Justering av snedhängande dörrar på MA-produkter

Adjustment of misaligned doors on MA products

Undre gångled / Lower hinge

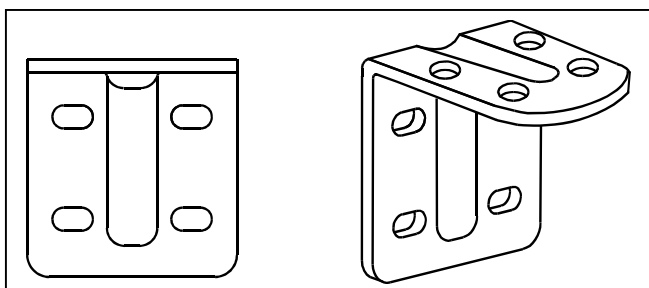
To allow adjustment of the lower hinge on a product with a misaligned door, hinges with oval holes can be ordered from DistriParts in Torsvik. Picture see below. These hinges can be adjusted ± 2 mm laterally.

To allow adjustment of the upper hinge, a hinge with double holes in the back is now available, see picture below. It can be ordered from DistriParts in Torsvik on kit number **96 00 16-88/9**. The kit contains also fitting screws. These hinges are valid for products with rounded doors.

Part number for **white** hinge: **205 69 52-08/4**

Part number for **grey** hinge: **205 69 52-06/8**

Part number for **black** hinge: **205 69 52-14/2**.
